project title:
**Proposed Development
Cleator Mills, Cumbria**

drawing title:
Site Plan

drawing number: 1701C PL - 200	revision: C
--	-----------------------

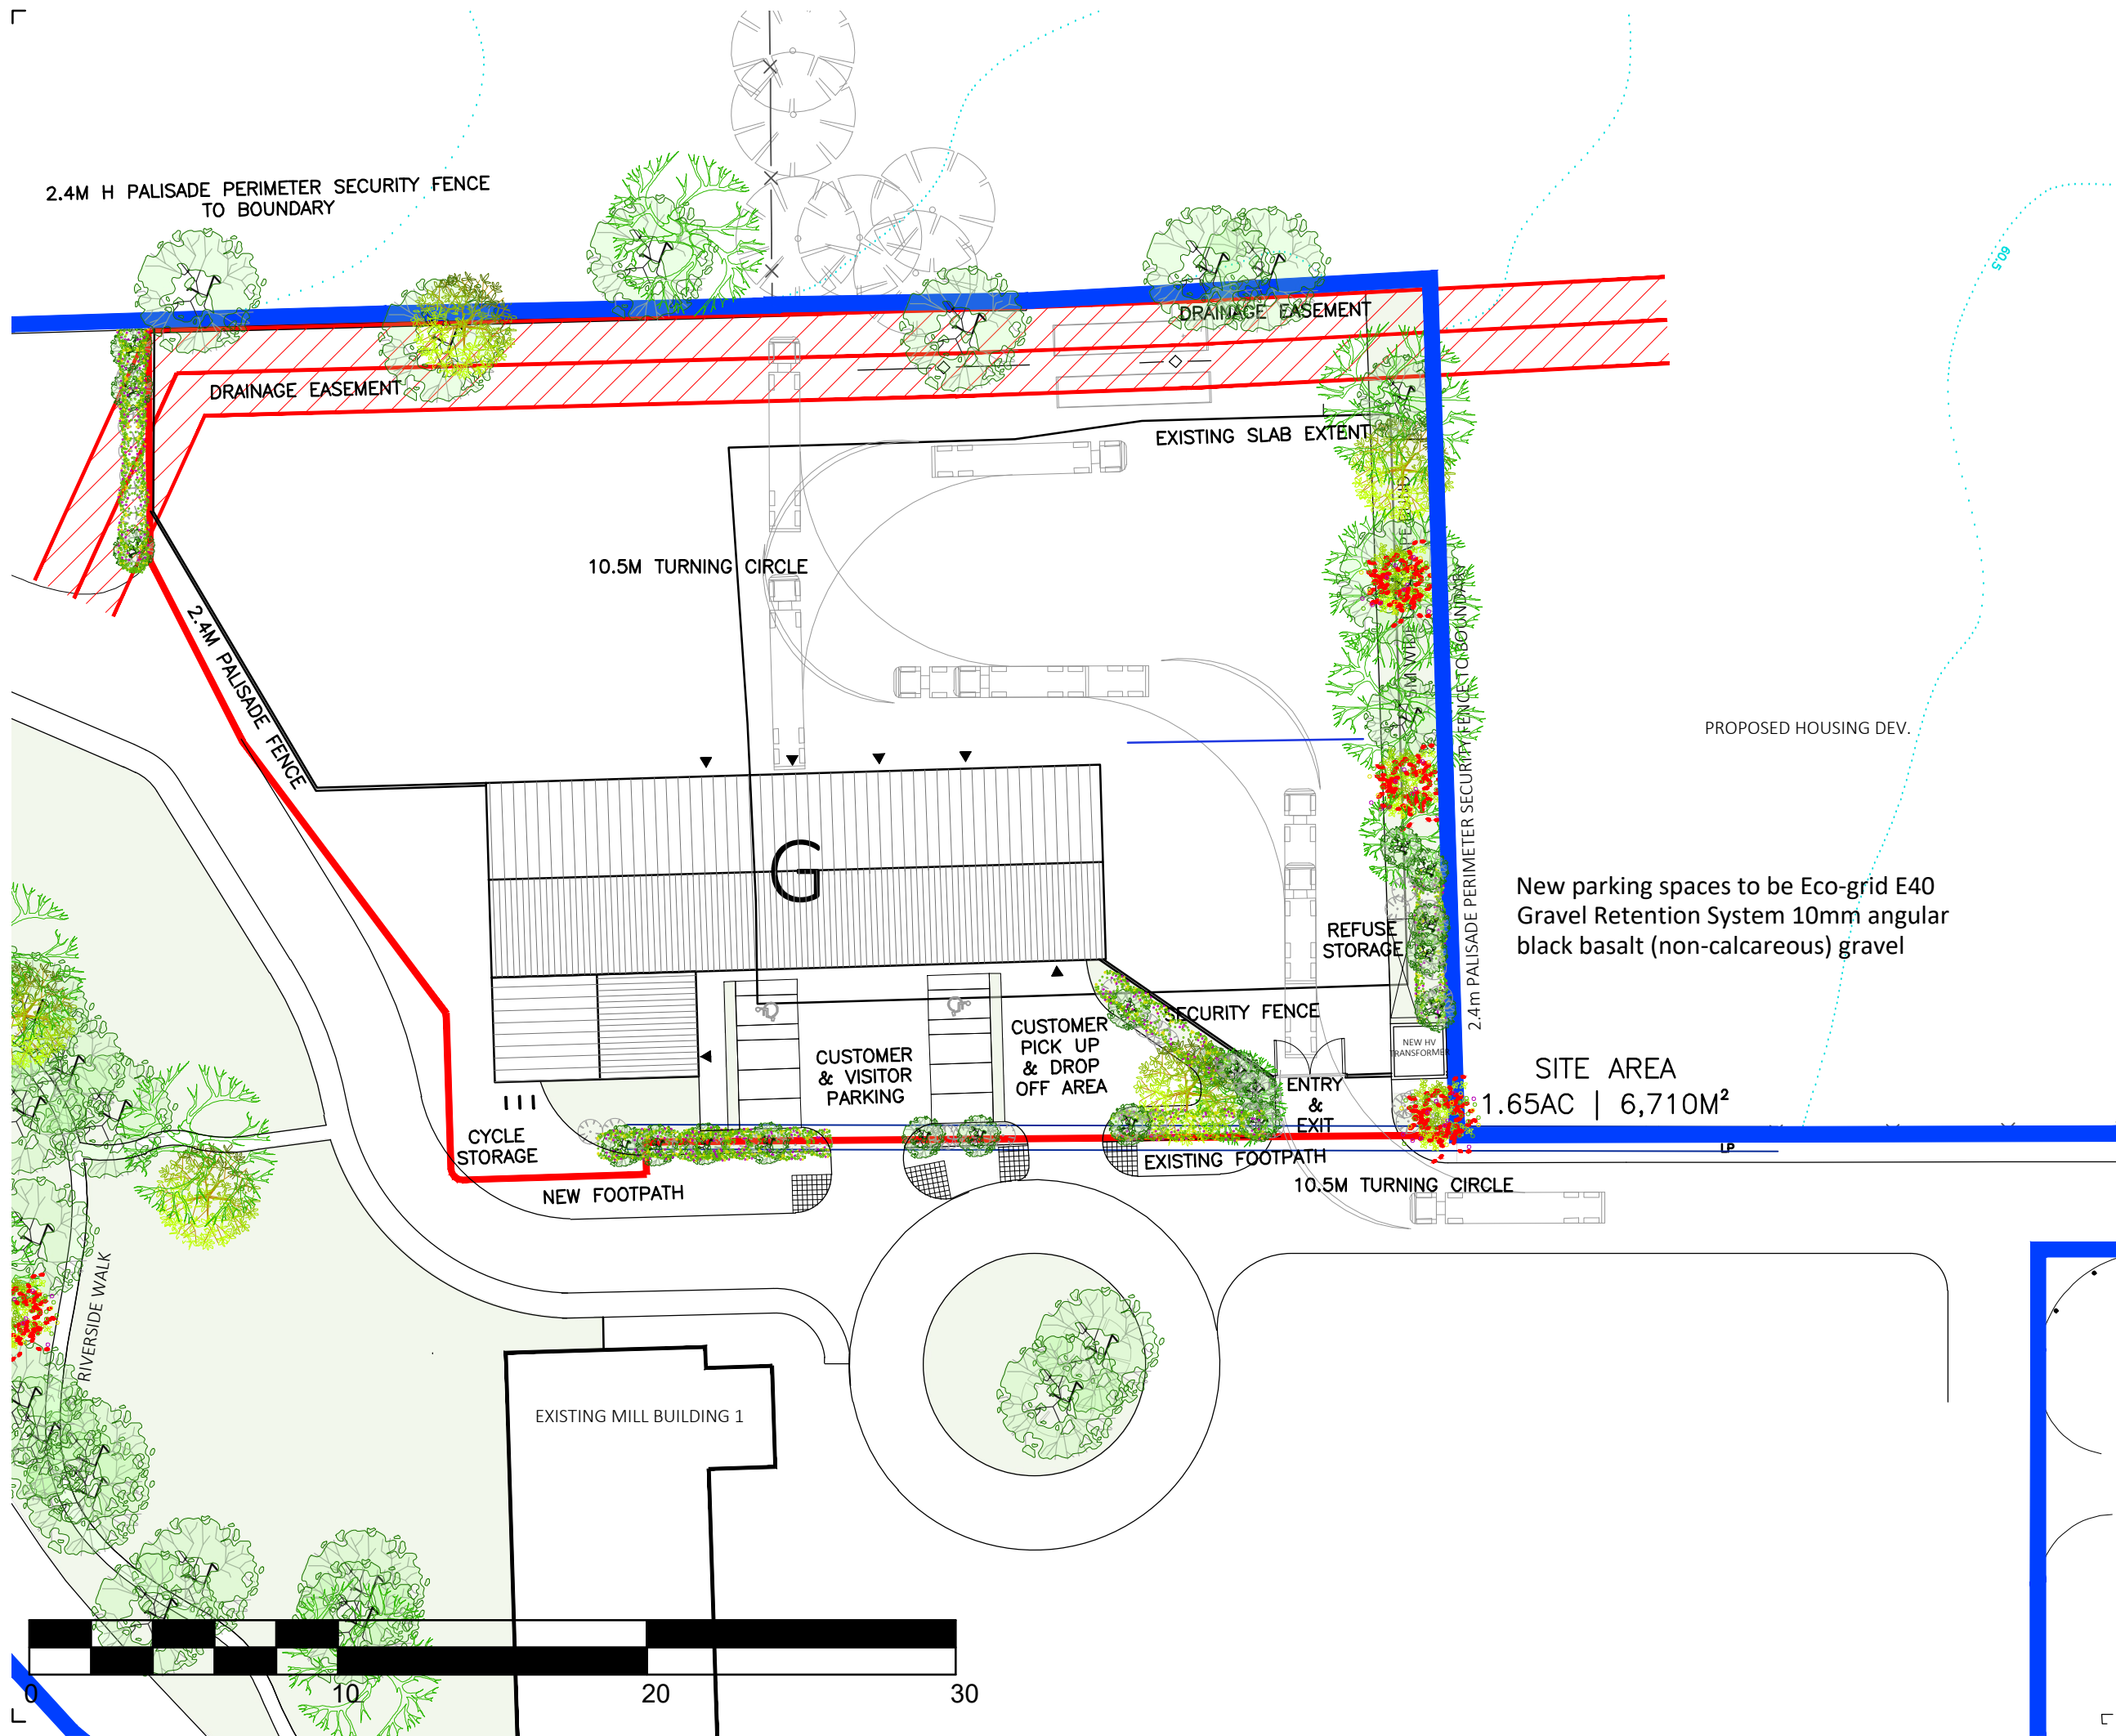
Revision A	CS/WM 06.10.2023
Revised following planning officer and client comments to improve parking and planting to building frontage. To be read in conjunction with Architectural Visualisations	
Revision B	CS/WM 13.10.2023
Building position adjusted and amended parking and landscaping to front of building.	
Revision C	CS 25.03.2024
Conceptual masterplan elements and withdrawn planning applications removed in clarification of proposed site plan
